**AGENDA ITEM:** #7 Plan Commission Recommendation (Carthage College):

**TO:** Village of Somers Plan Commission  
**FROM:** Luke Godshall, Kenosha County Planning & Development  
**RPT DATE:** 08-26-22  
**MTG DATE:** 09-12-22  
**APP DATE:** 08-02-22  
**RE:** Carthage College Facilities Operations Building

**Review Comments – September 2022 Planning Commission**  
Carthage College – Operations Building  
09-15-2022

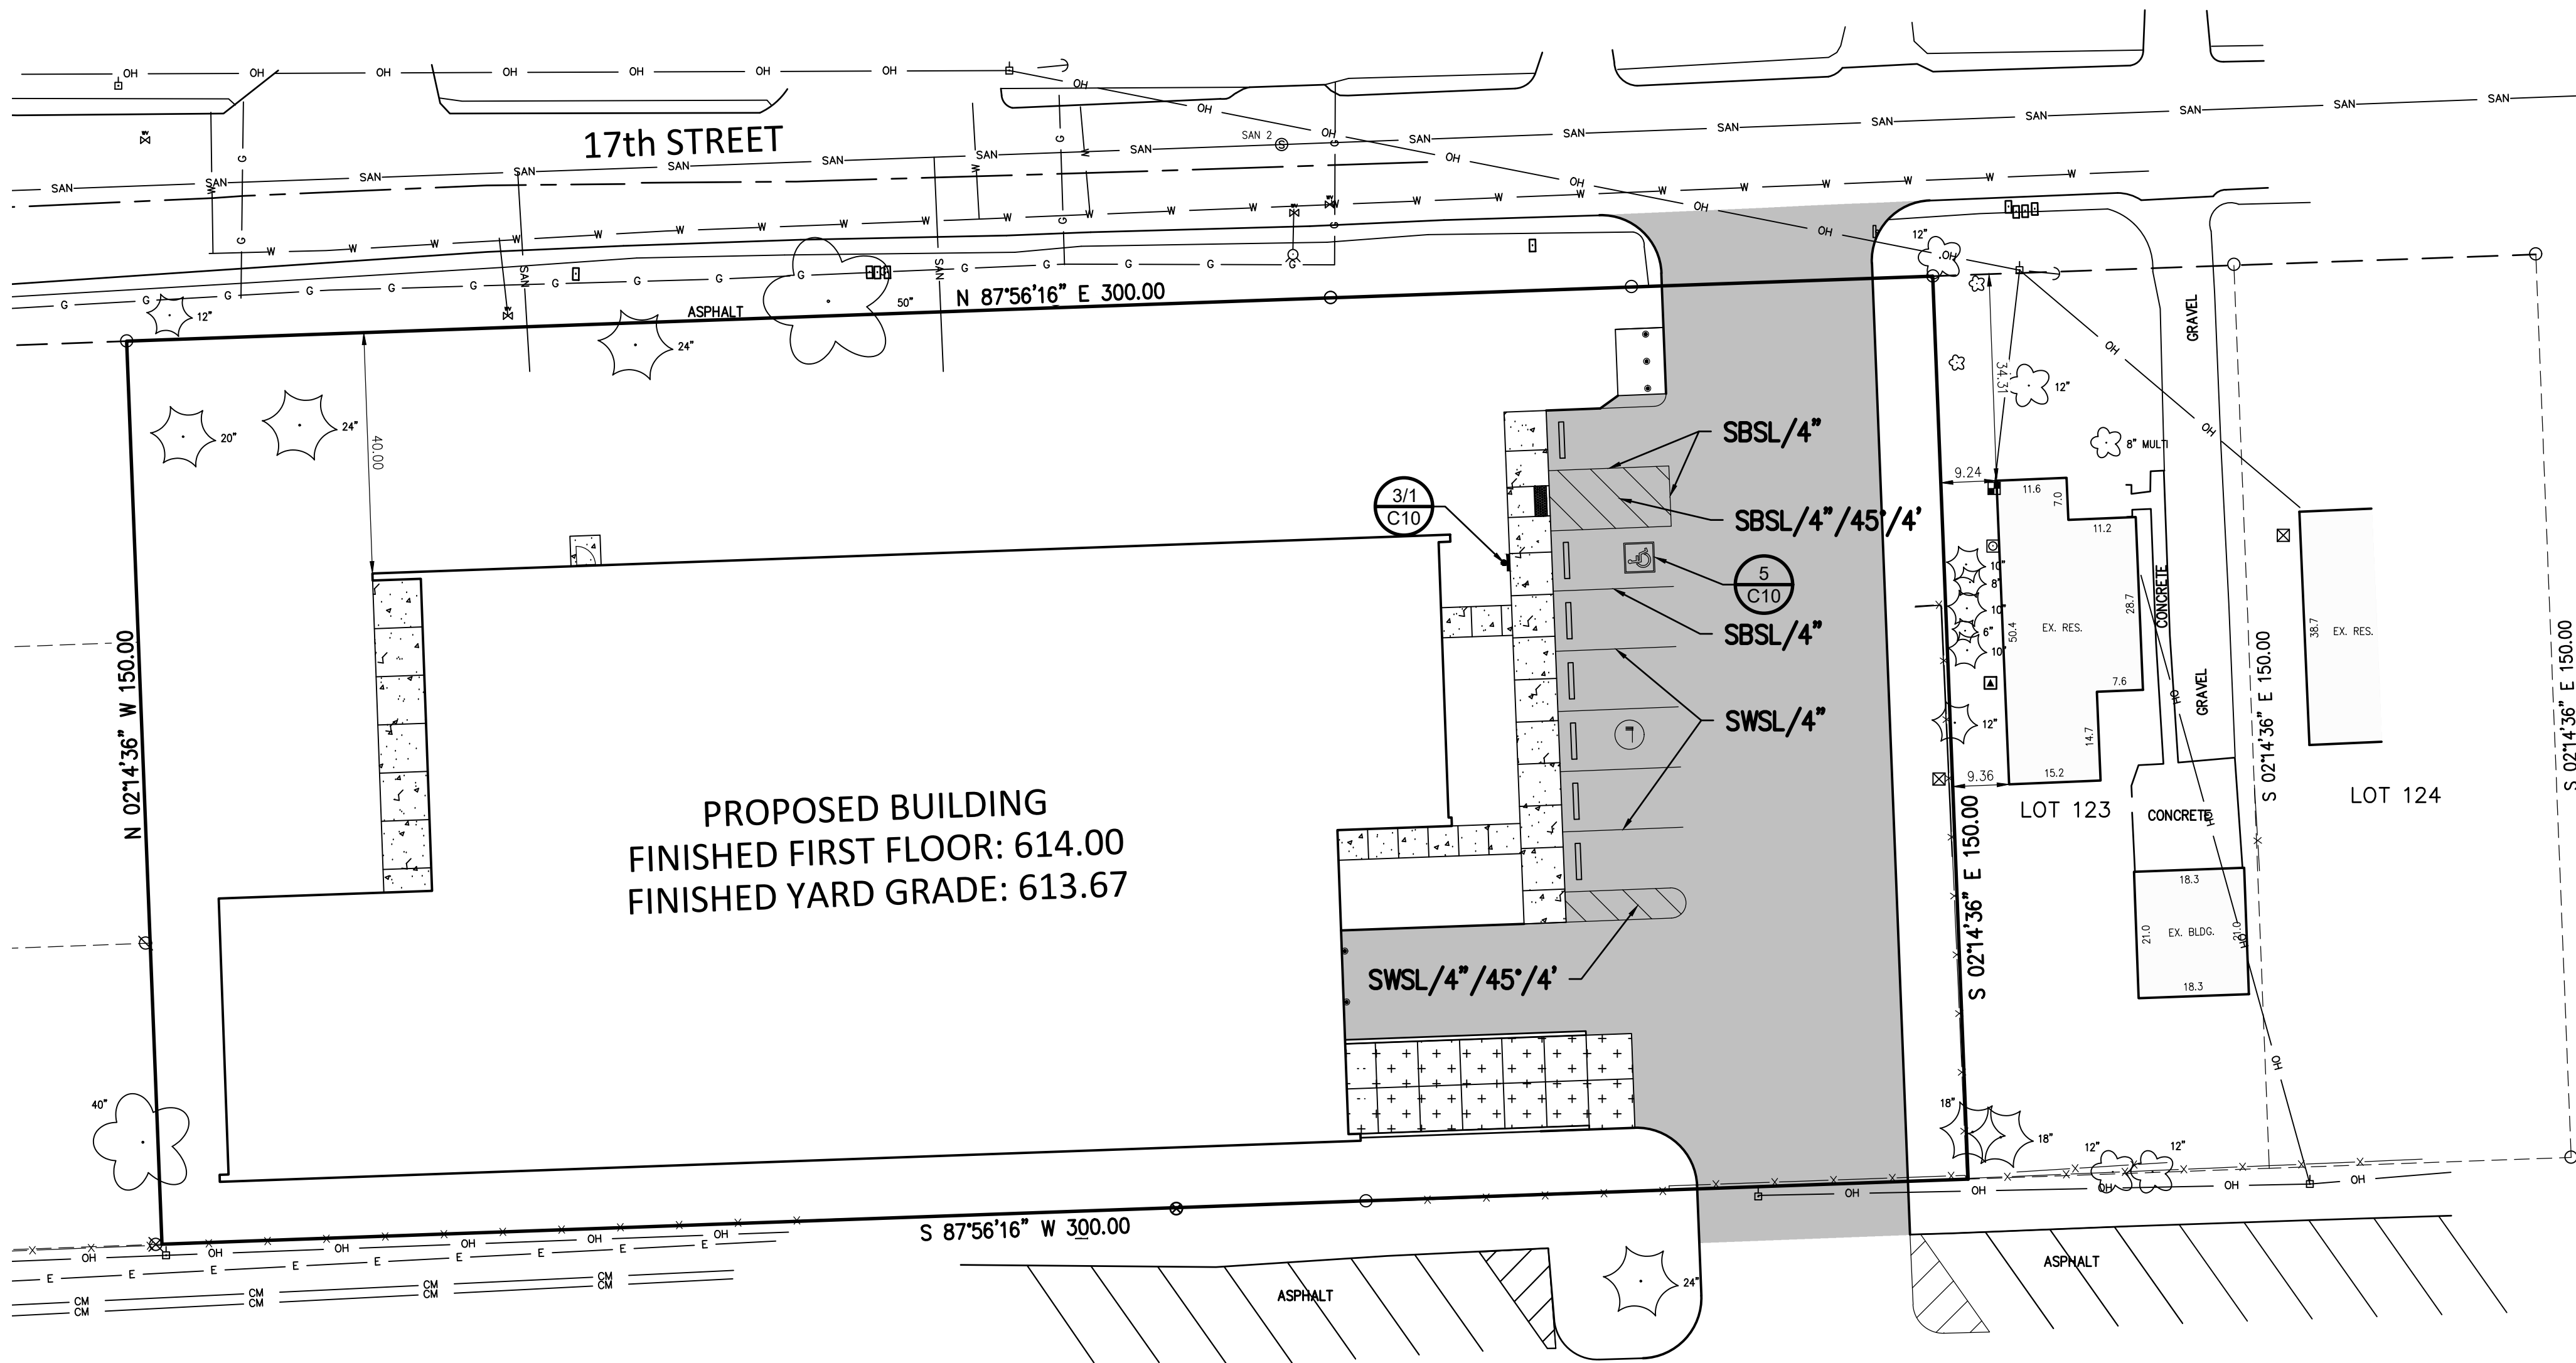
- ☐ Spacing: Maximum 400 feet (residential subdivisions).
    - ☐ Place locator wire terminal boxes at all hydrant locations.
6. On Sheet C5 (Site Grading & Erosion Control Plan):

- a. Show proposed grading in the 17<sup>th</sup> Street right-of-way to facilitate proper drainage from the proposed parking lot and northerly portion of the building toward the west.

- b. Show erosion mat on all slopes 4:1 and greater.
7. On Sheet C411 (Typical Section & Construction Details):
  - a. Provide a sanitary sampling manhole detail similar to the one in the *Standard Specifications for Sewer & Water Construction in Wisconsin*.

SITE PLAN

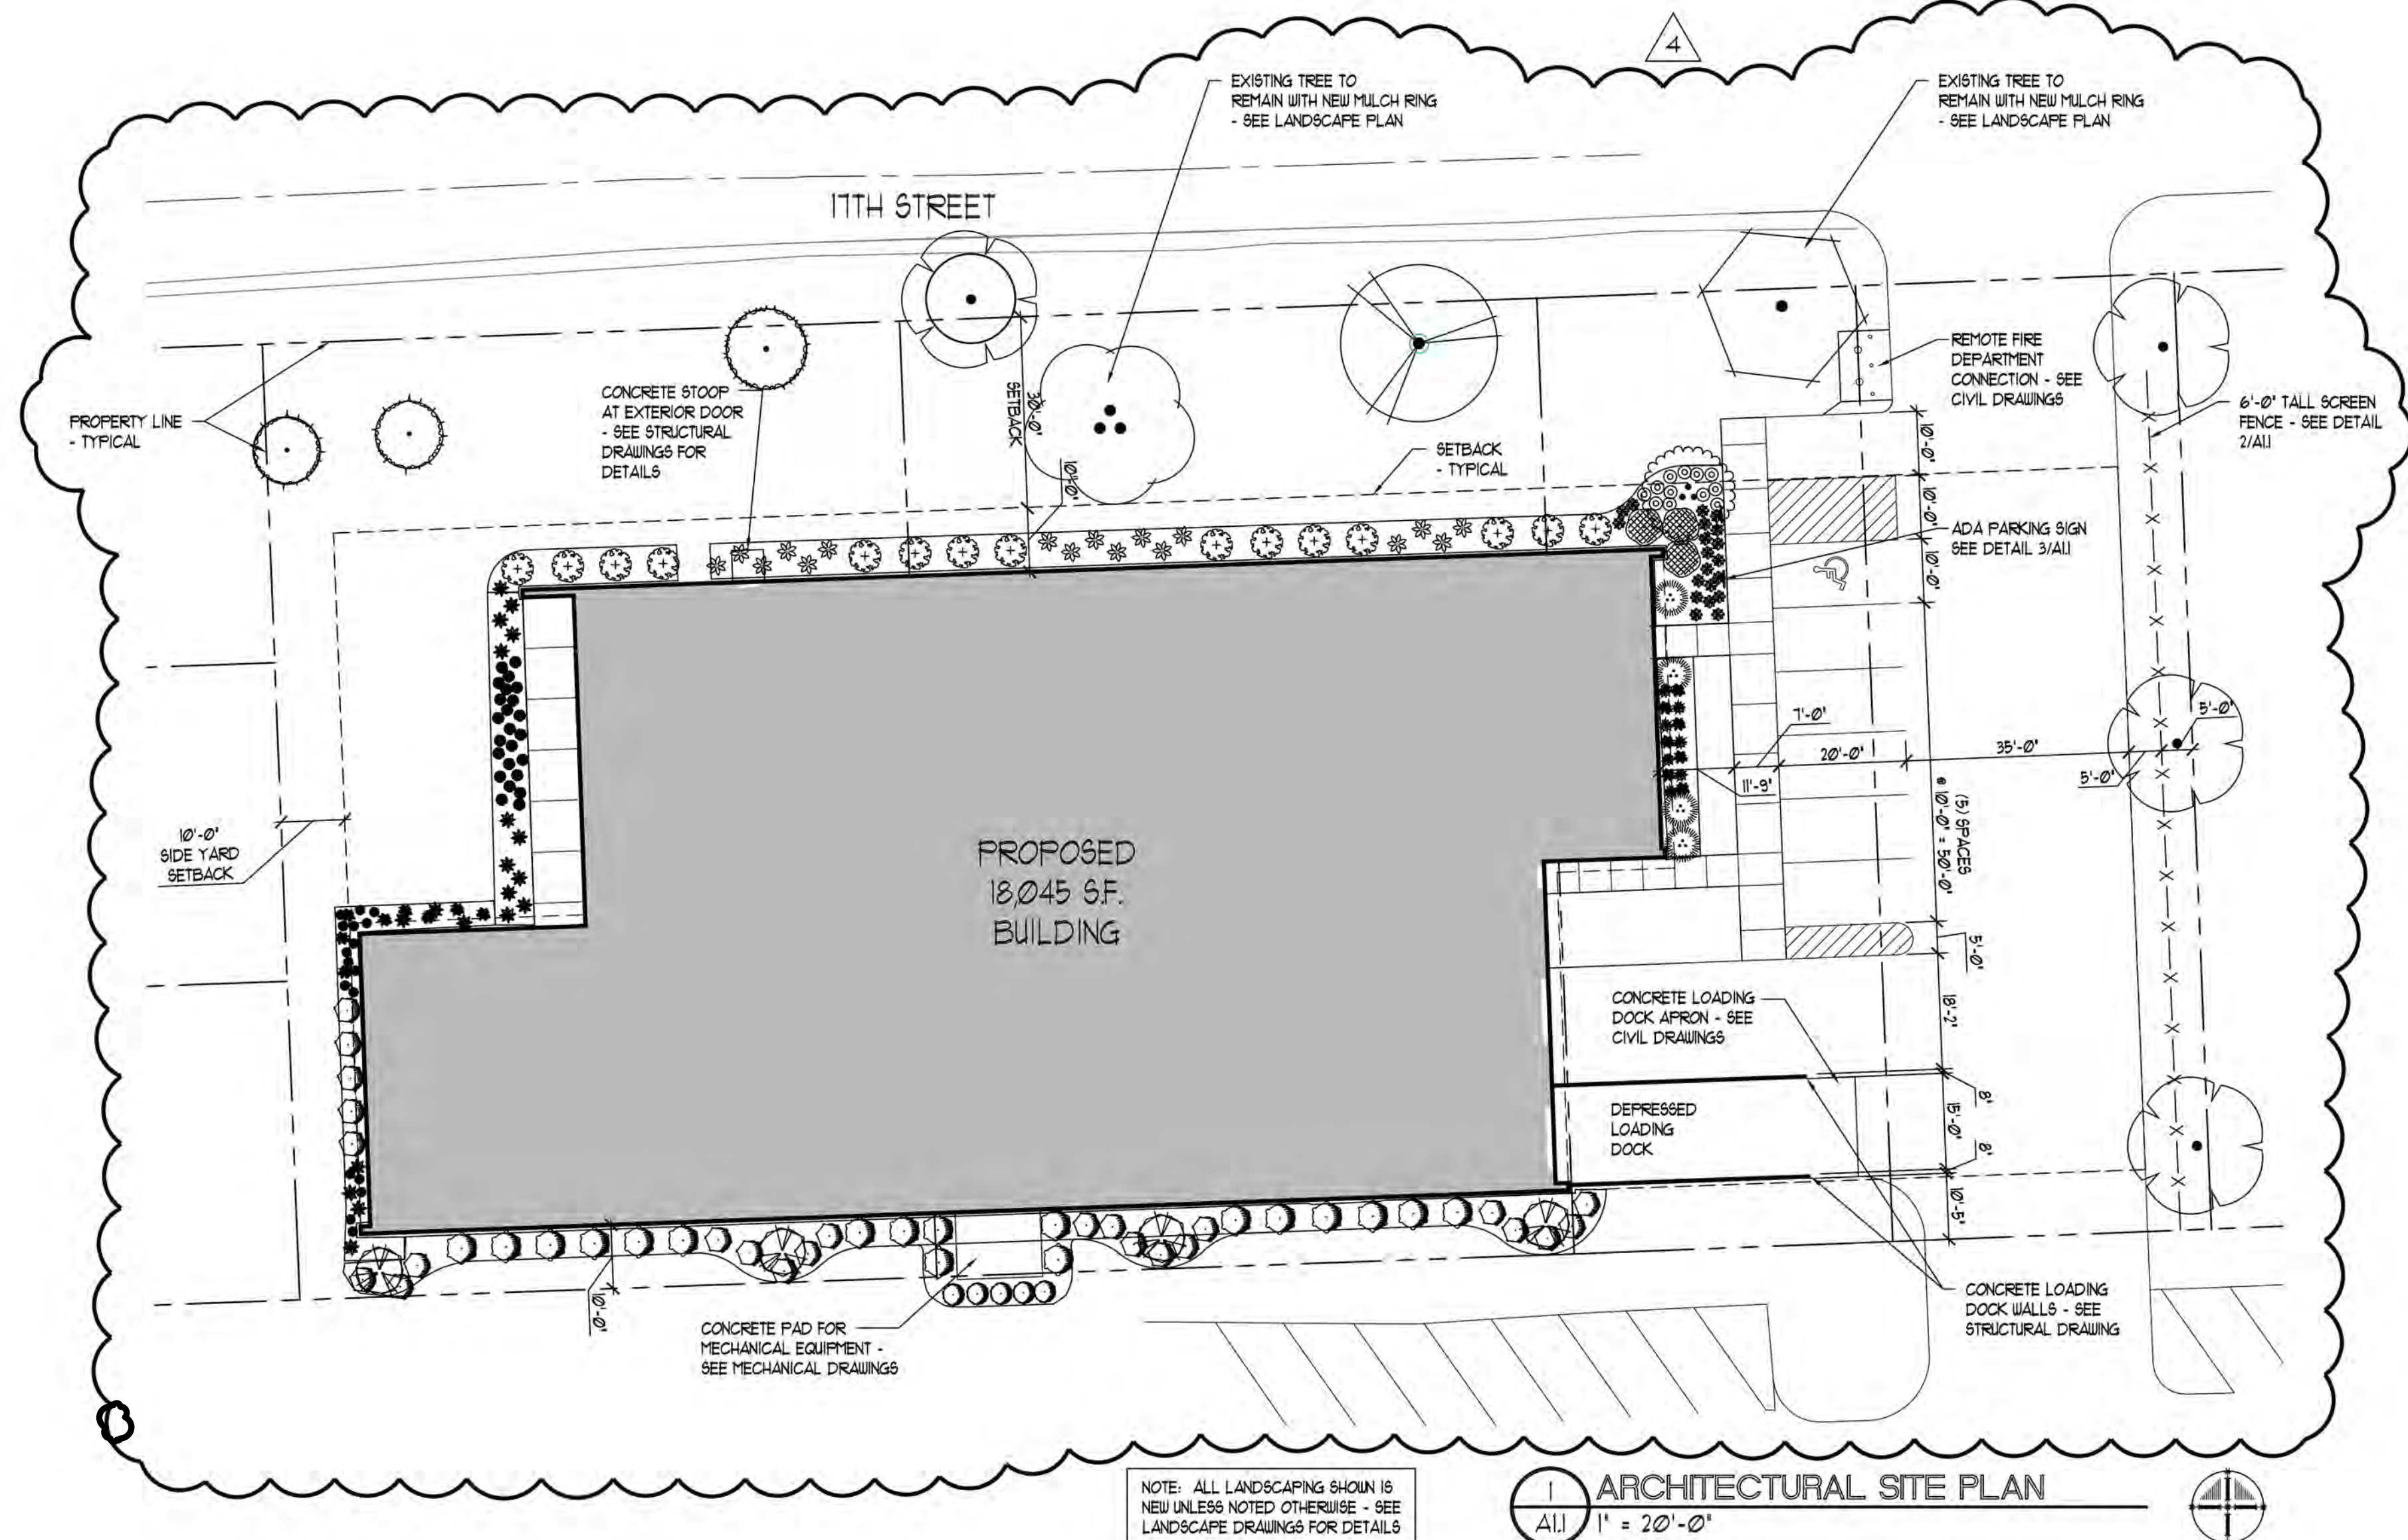
- b. See comment 4b above.
8. On Sheet A1.1 (Site Plan), there needs to be 5' of clearance below the "Van Accessible" sign in the ADA Bollard Sign Detail.
